Addendum No. 2

WELL DRILLING AND CONSTRUCTION FOR AMERICAN FLAT ROAD AREA IPR FEASIBILITY

PWP Bid No.: WA-2018-253
TMWA Capital Project No.: 15-0048
September 11, 2018

ATTACHMENT B
PROPOSED WELL LOCATION MAP (3 Wells)

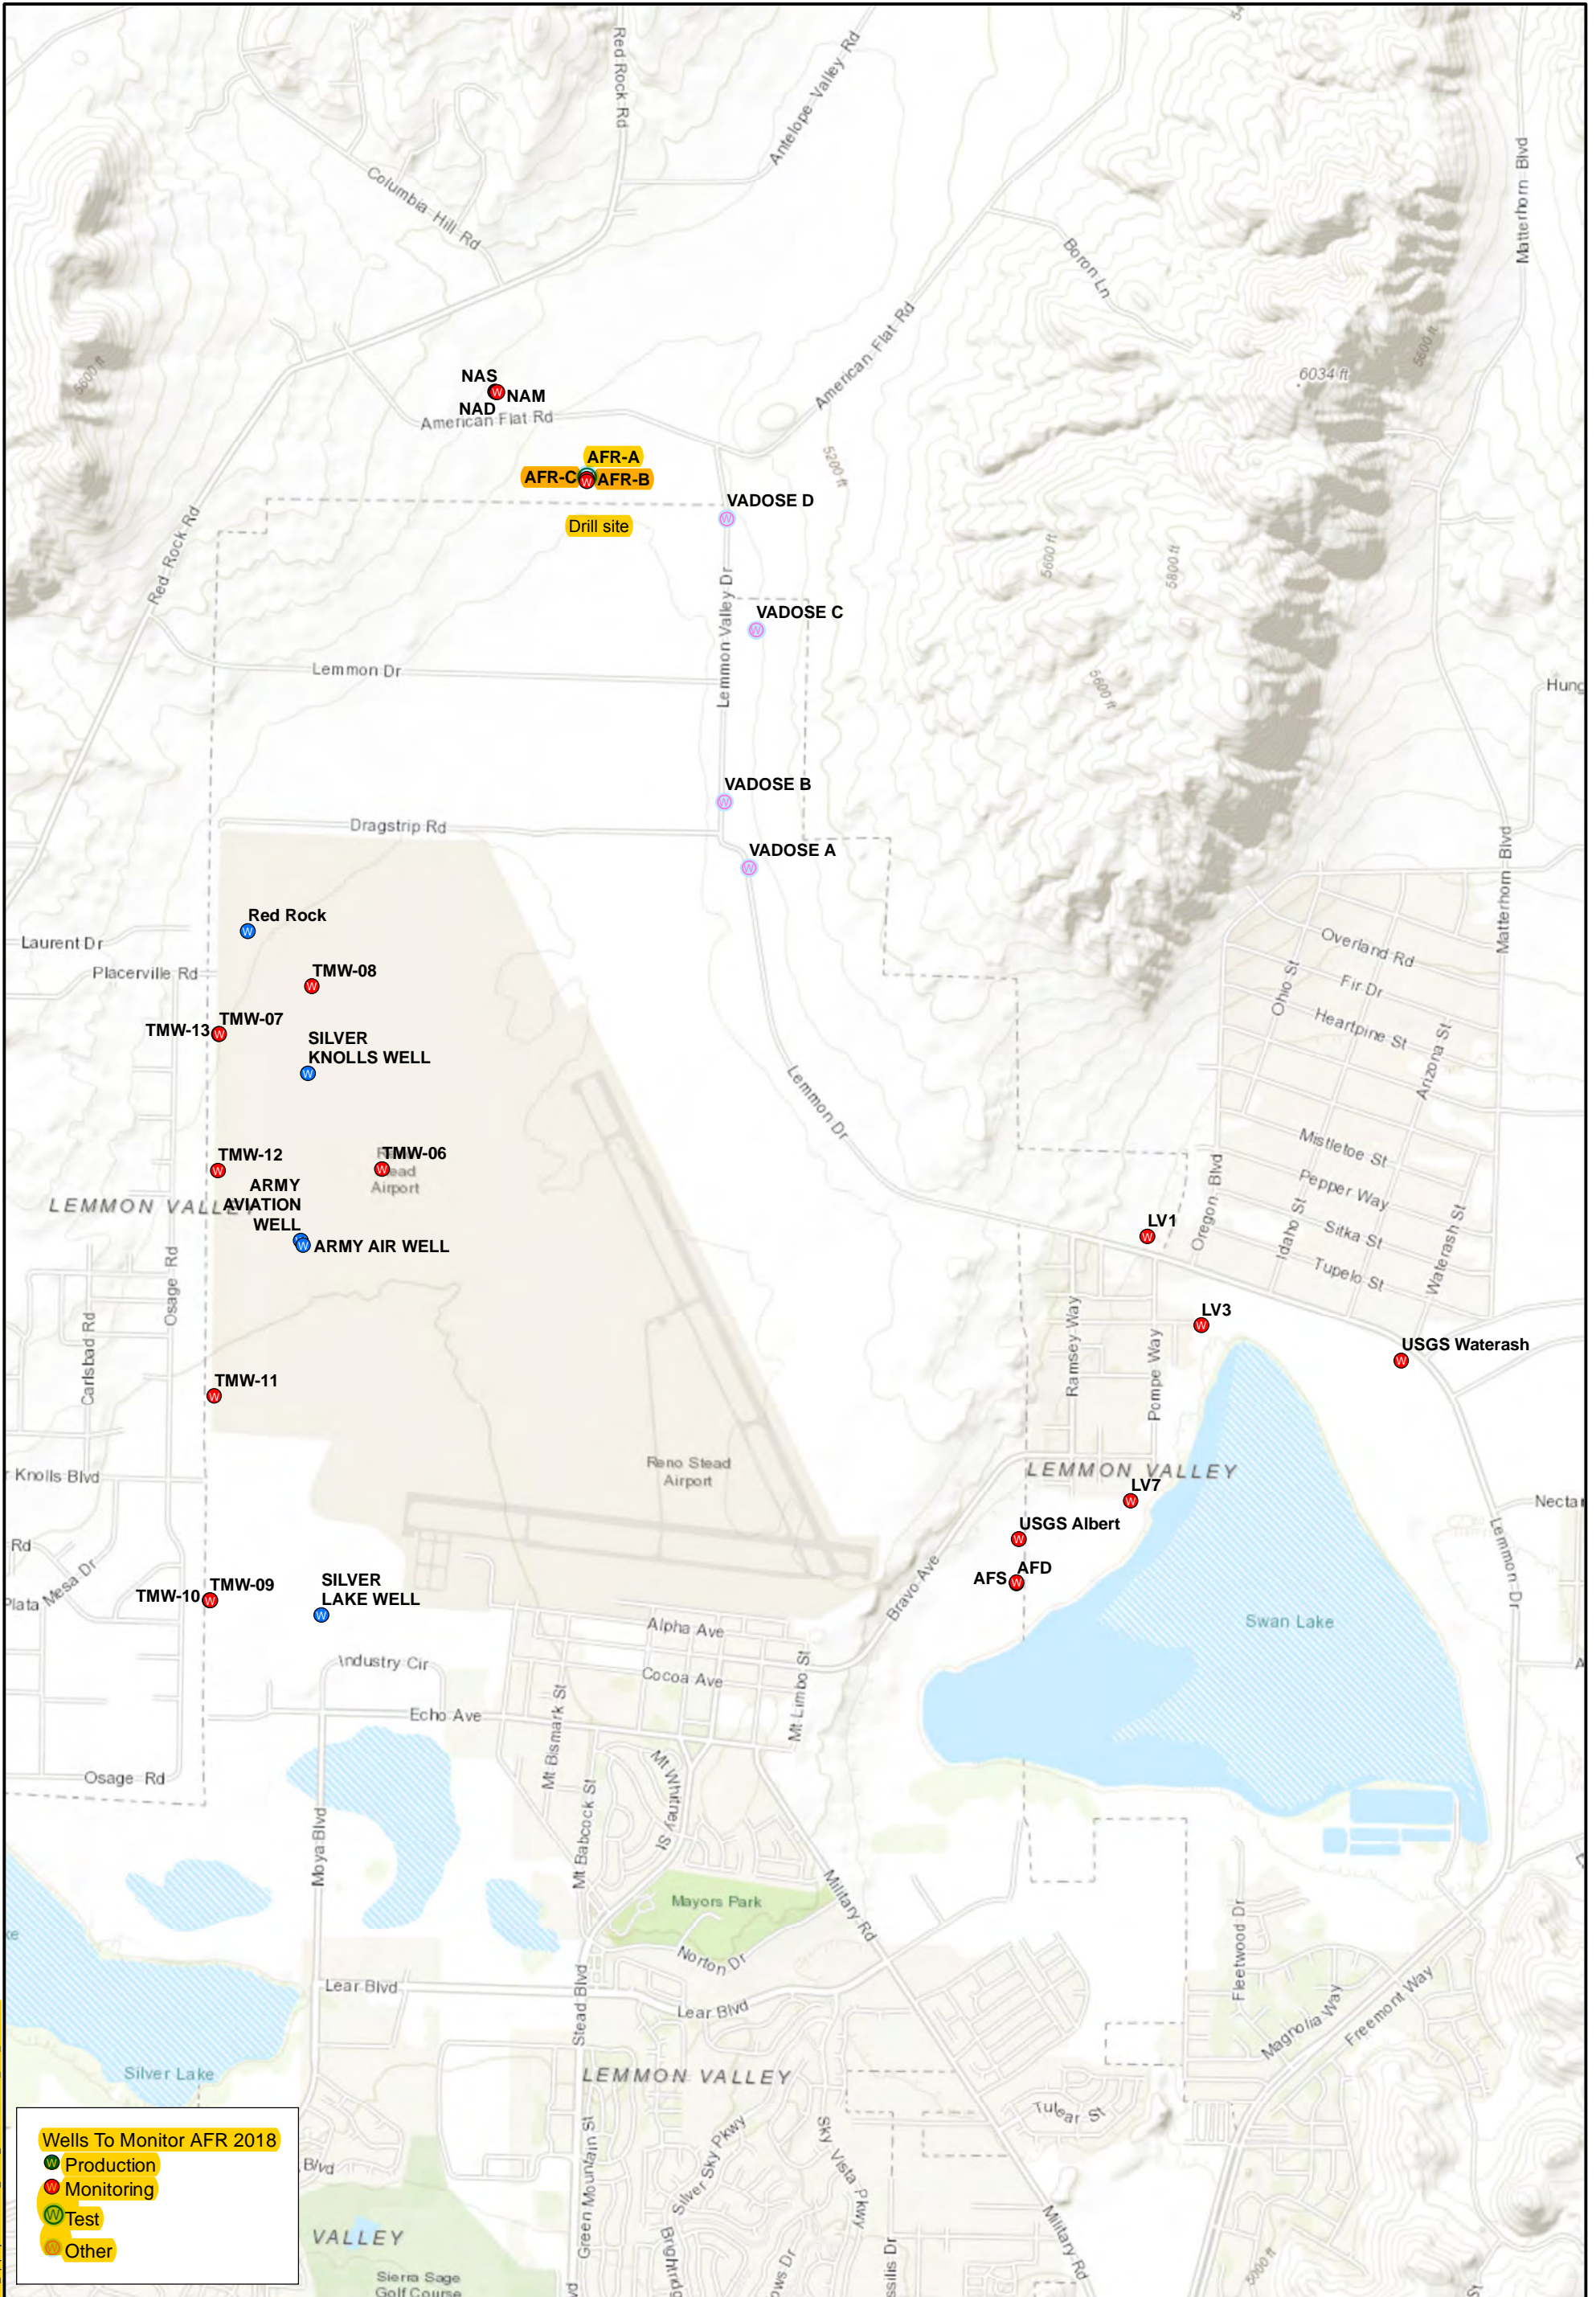
Question No. 1: The information currently does not identify the exact locations for the 3 wells within the proposed drilling block. Could you please provide that information?

Response to Question No. 1: Proposed well location map is included as Attachment B. The three wells will be within approximately 200 feet of each other.
